This letter is a request to an amendment to AP.CO's Source Material License #SUA-1470, for the following items:

Design Modification Amendment Request

ARCO Bluewater Mill
Reclamation Plan

LICENSE NO. SUA-1470
DOCKET NO. 40-8902

FIGURE 1.1
CARBONATE TAILINGS
NEW & OLD BOUNDARY

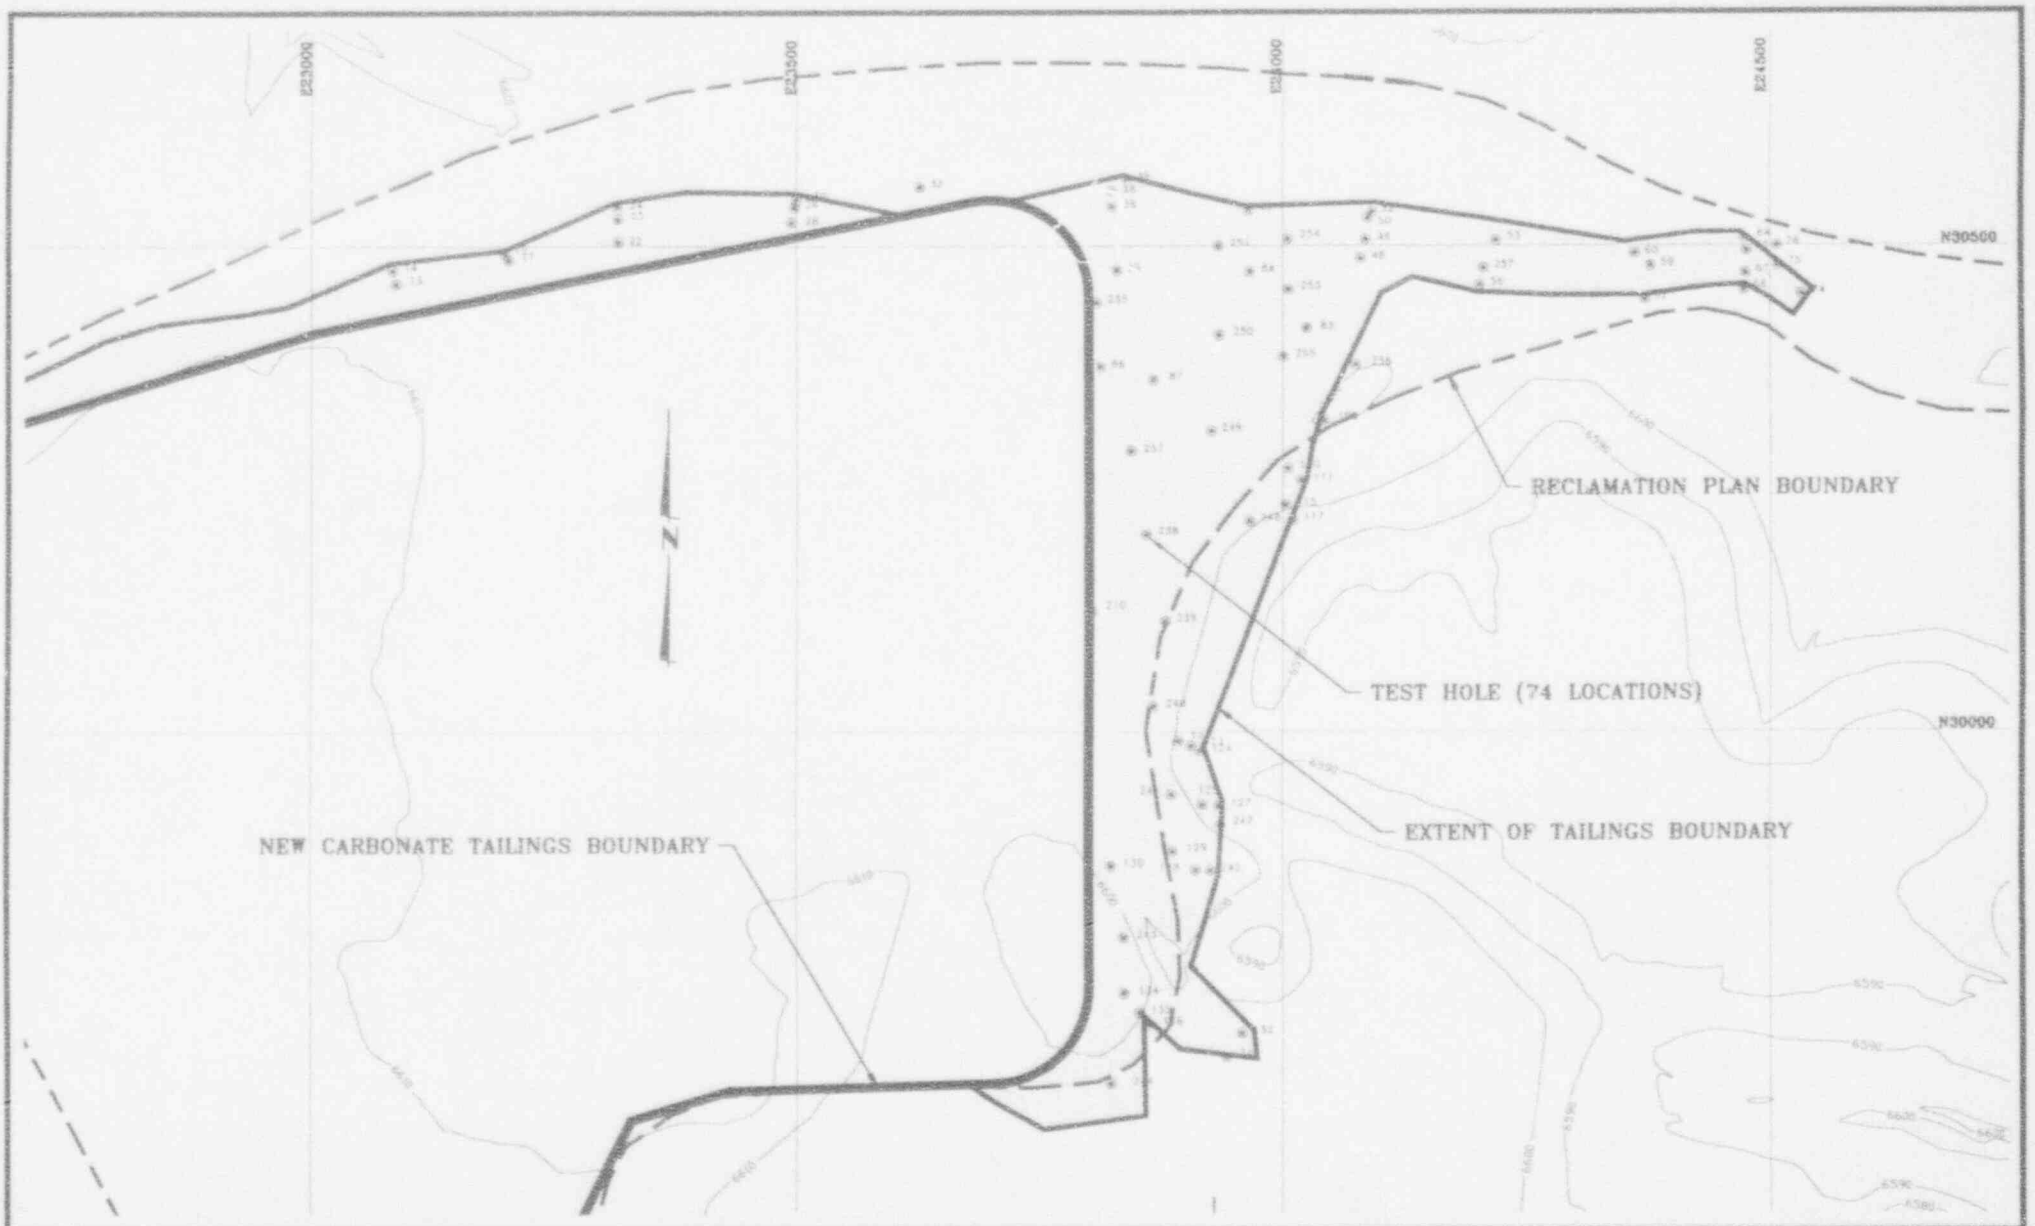
ARCO proposes to make adjustments to the configuration, depth of radon cover and surface erosion protection on the Carbonate Tailings. Since approval of the reclamation plan ARCO has undertaken an exploration program to better identify the aerial extent of the Carbonate Tailings. The results of this exploration have identified the main body of Carbonate Tailings on the eastern side of the impoundment to be smaller than originally anticipated. The main body tailings has been defined as the area where tailings have significant depth. Many areas surrounding the impoundment were discovered to be shallow and uneven. Figure 1.1 illustrates the original boundary and the new boundary developed following the exploration program.

Two of the three Bluewater Mill disposal areas reside within the boundary of the Carbonate Tailings as shown in Figure 1.1. During decommissioning of the Mill these areas were filled with debris and soil. In determining the final design configuration for the Carbonate Tailings, ARCO has re-evaluated the cover requirements taking into account the layers of debris and soil. These modifications have been incorporated into the overall design of the Carbonate Tailings.

FIGURE 1.3
CARBONATE TAILINGS
FINAL TOPOGRAPHY

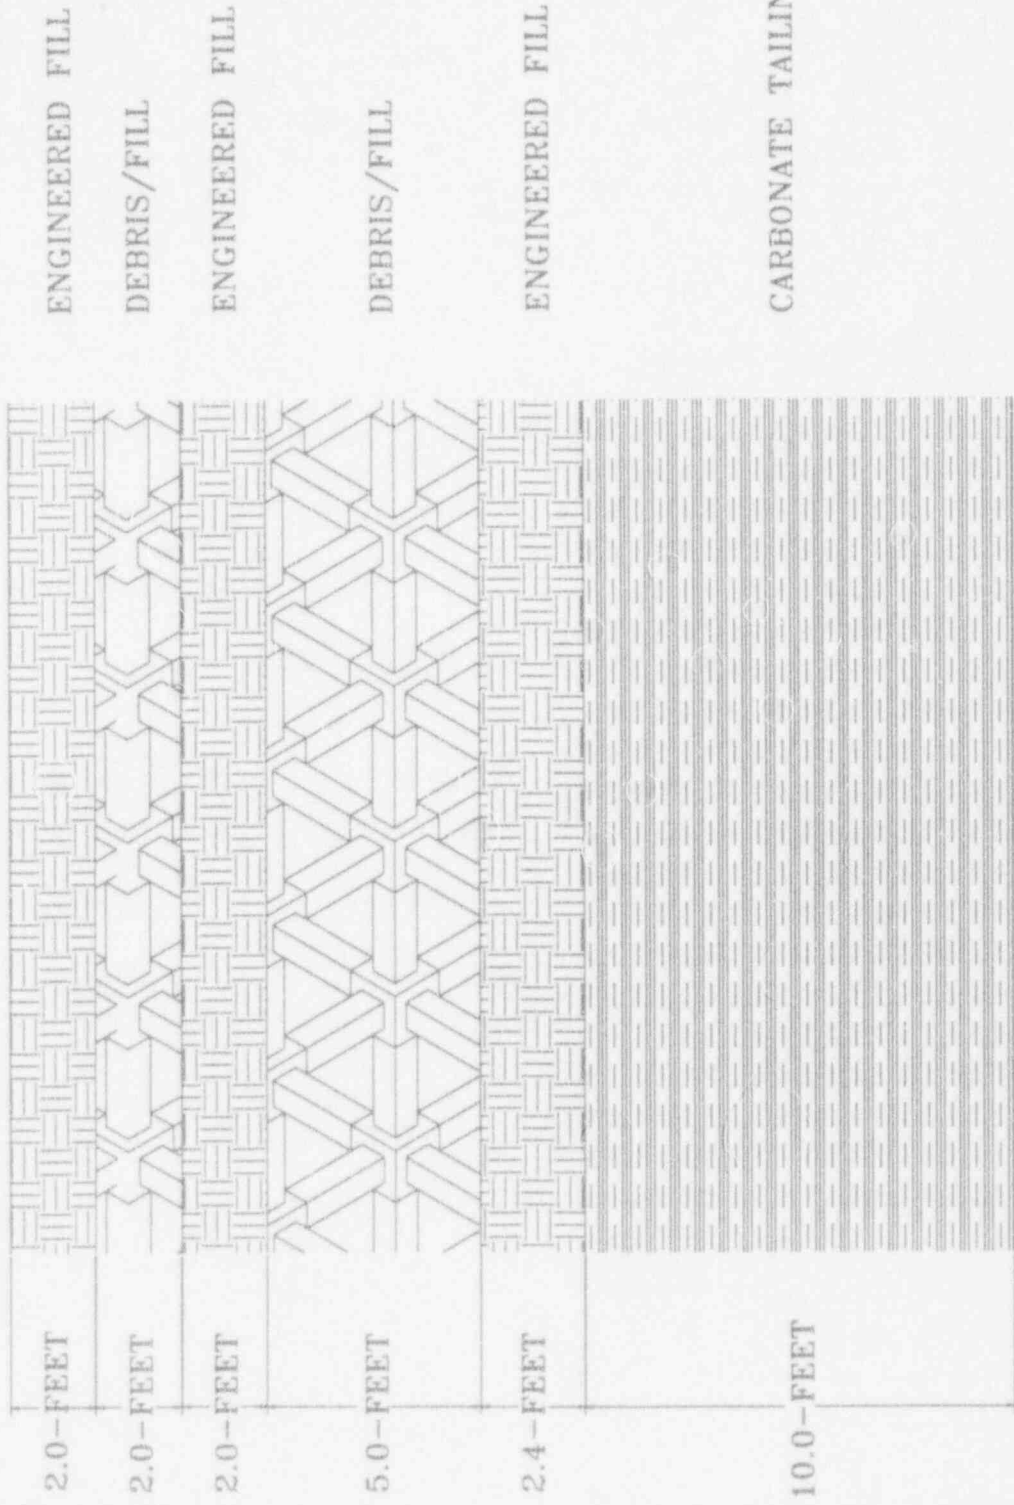
Drawing 1.3 shows the modified surface configuration for the Carbonate Tailings which take into account the modified cover requirements.

TYPICAL CROSS SECTION
DISPOSAL AREA #2
FIGURE 1.4

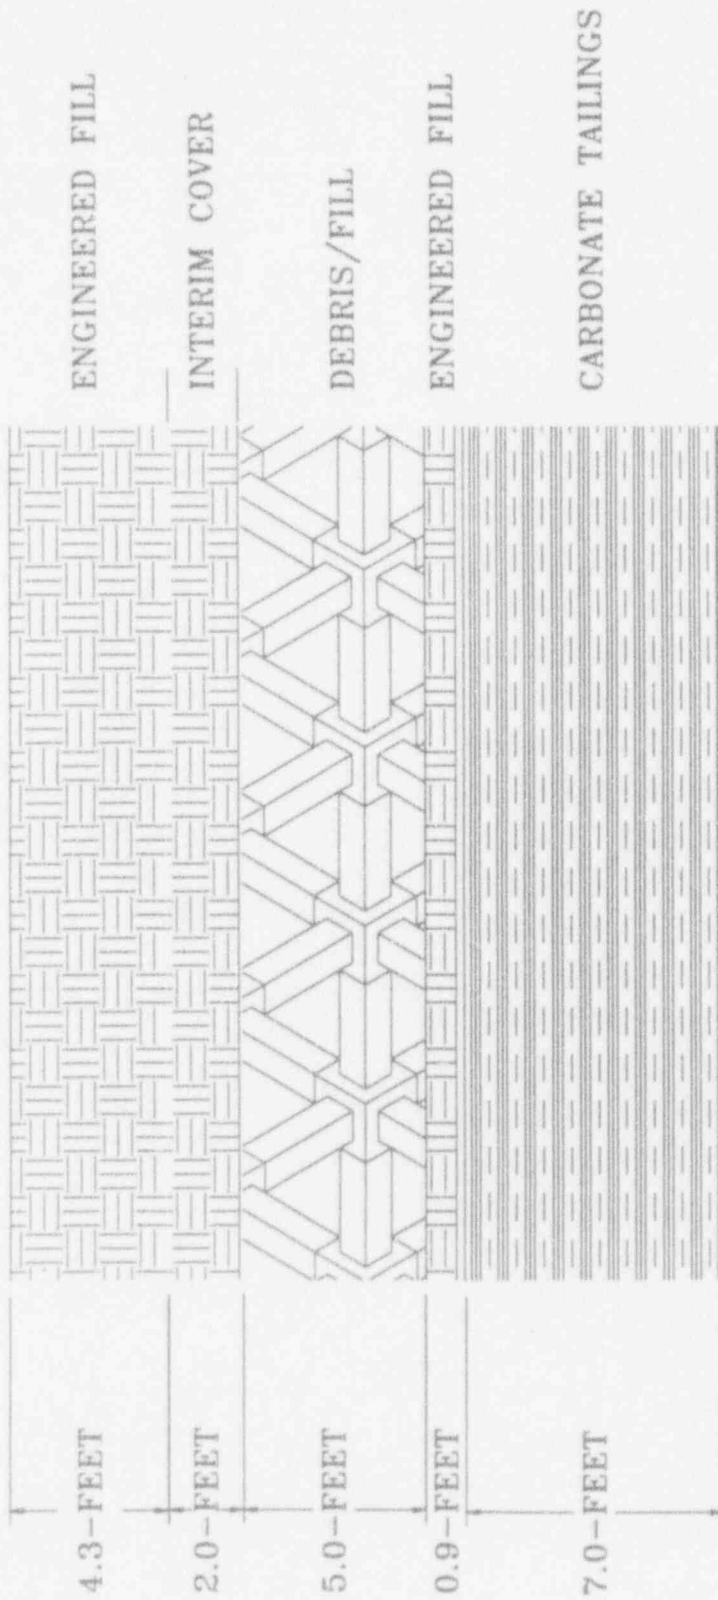
The northern area of Disposal Area #2 received two lifts of debris and soil, with depths of 5-feet and 2-feet respectively. Each lift of debris with interstitial soil has been covered with a 2-foot layer of engineered fill.

The RAECOM model for cover thickness requirement in this area was modified to include the two lifts of soil/debris and engineered fill on the disposal area. Input for the model is derived from parameters prepared by Rogers and Associates, the Roy F. Weston Report for ARCO's Reclamation Plan and ARCO's Final Radon Barrier Design Report, December 1993. A profile of current conditions is shown on Figure 1.4. The calculated model shows that no additional cover is required in this area to meet the 20pCi/m²/s radon flux.

FIGURE 2.1
SOUTH BENCH
EXTENT OF TAILINGS

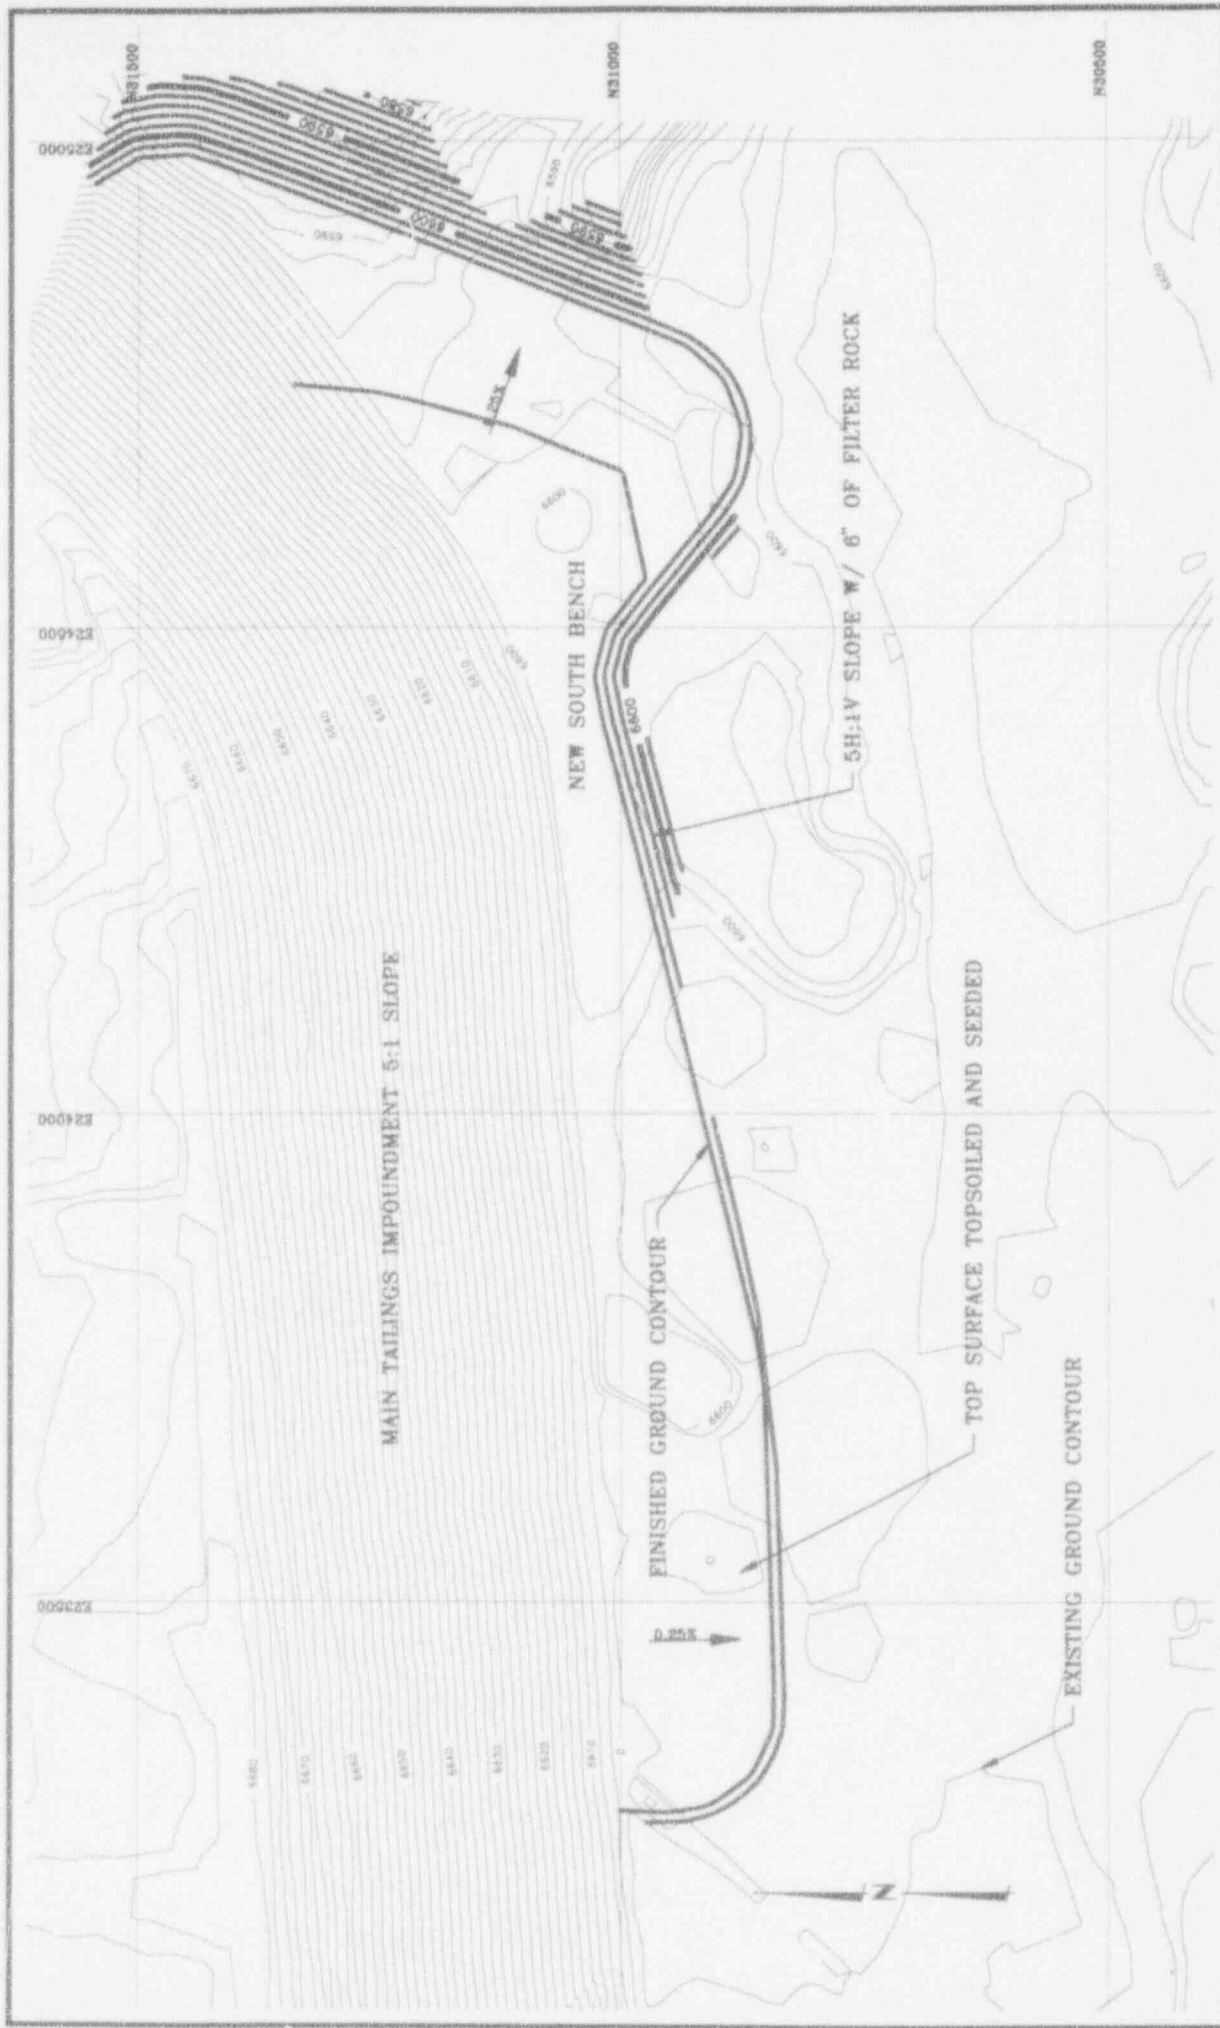
The area south of the Main Tailings Impoundment at the toe of the 5:1 slope between Station 113+00 and Station 123+00 has been determined to contain tailings materials. Figure 2.1 provides a plan view of this area showing the extent of the tailings material. The tailings material found varies in thickness from several feet to over seventeen feet in depth. ARCO proposes to cover these areas with an approximately 3.4-feet of radon barrier, a depth similar to that designed for the Main Tailings Impoundment embankments in the original 1990 Reclamation Plan.

FIGURE 2.2
DESIGN CONFIGURATION
SOUTH BENCH

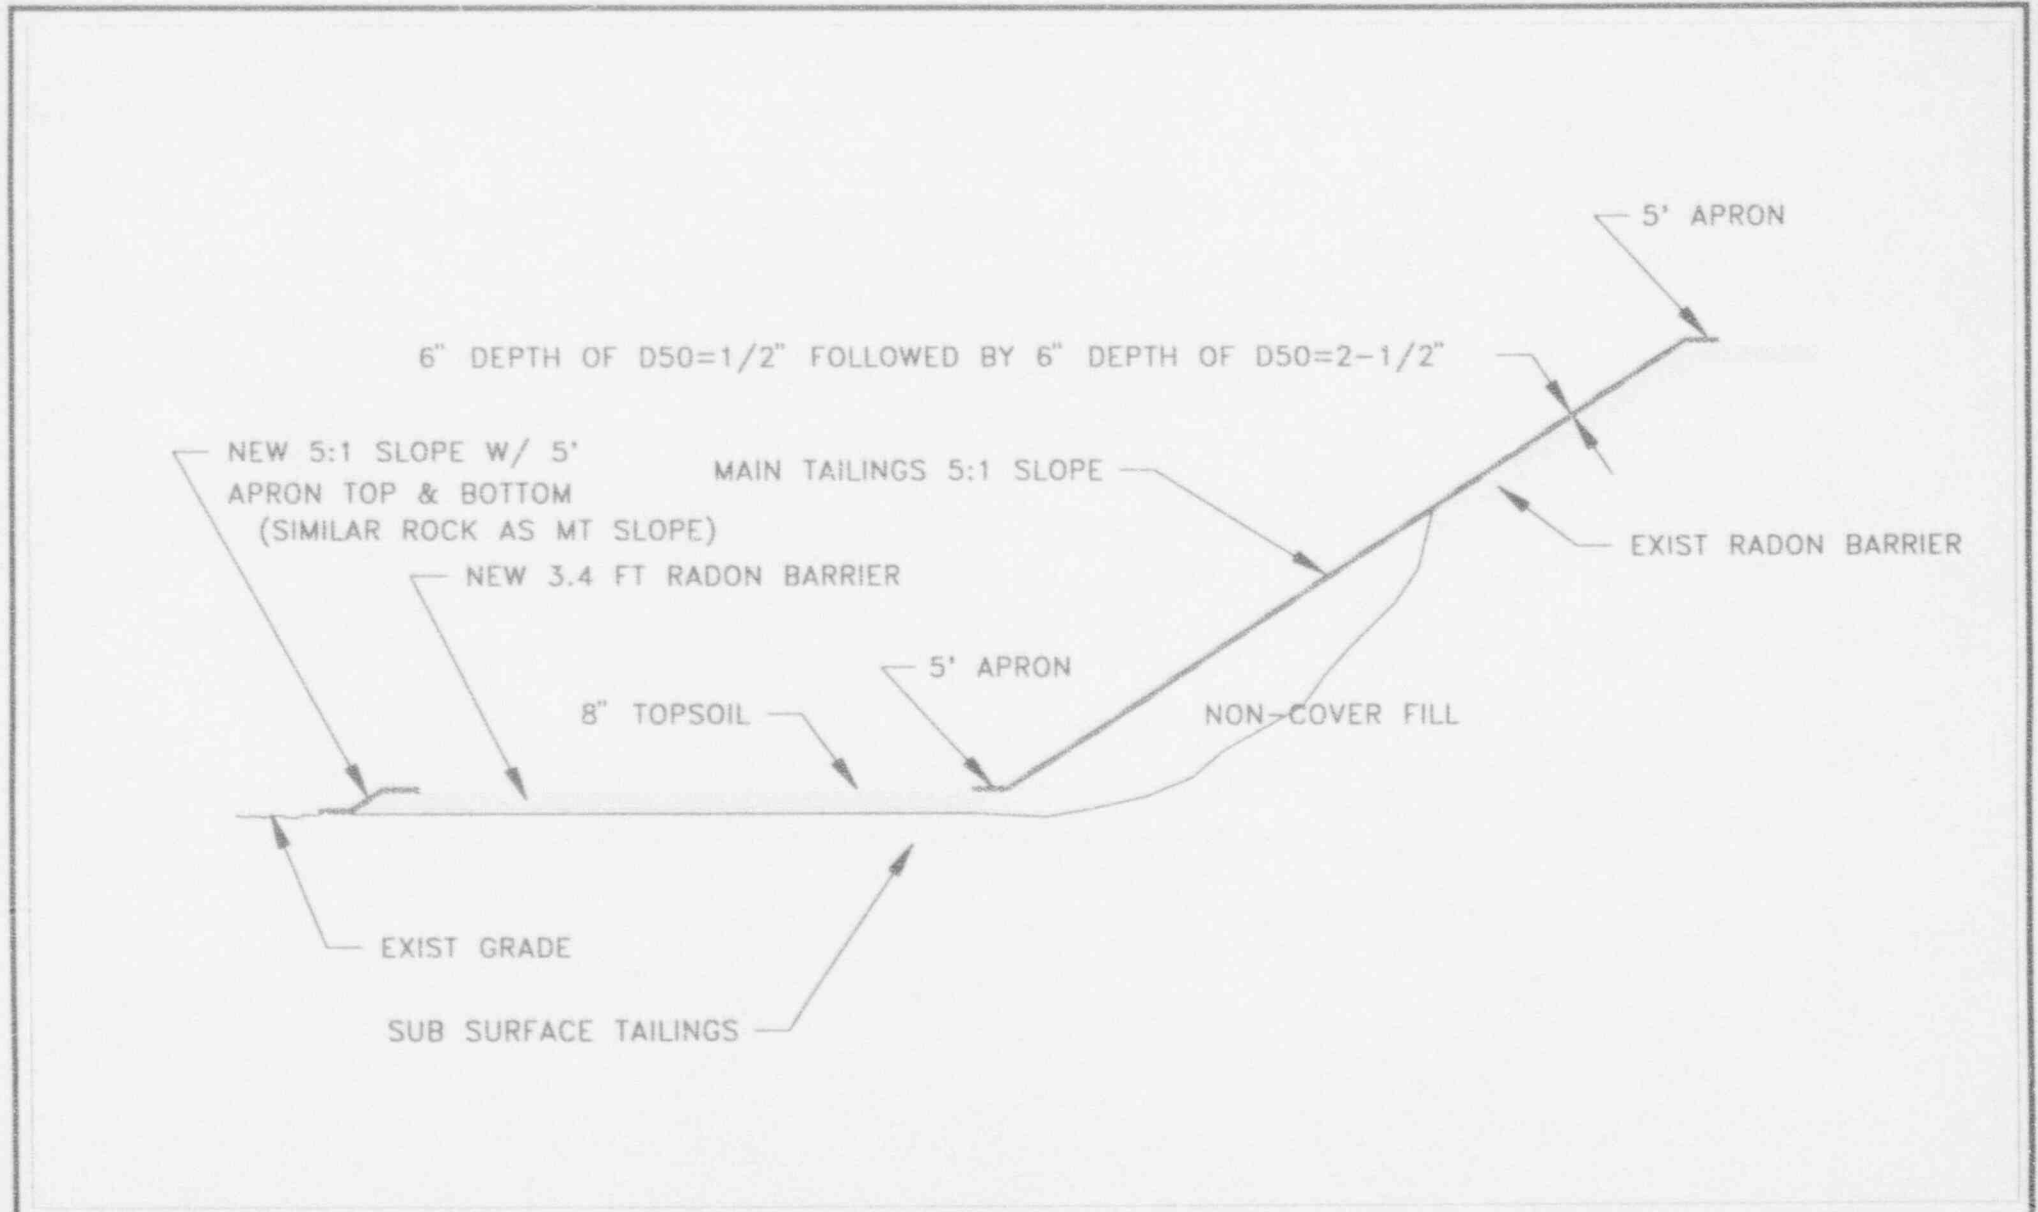
RAECOM models indicate that 1.2-feet of cover is the maximum cover this area requires to attenuate radon levels to NRC criteria. A depth of 3.4-feet has been placed over this tailings material which is consistent with the radon cover on the adjacent Main Tailings Impoundment embankment slopes. The log hole information for the south bench area and the RAECOM calculations for this area are attached in Appendix B. Radium concentrations used in the design of the cover were determined from field samples collected at several locations within the area. The physical properties of the tailings are similar to those found in the Old Acid Tailings. In addition, early aerial photographs indicate that deposits were made during the same period as the Old Acid Tailings. RAECOM calculations use the physical characteristics of the Old Acid Tailings with the measured radium concentrations of field samples taken. Figure 2.2 shows the complete design configuration of the South Bench. A typical cross section of the proposed South Bench is shown in Figure 2.3.

The top surface of the South Bench has been designed to meet stable slope criteria. The stable slope calculation is included in Appendix B with this report. Following
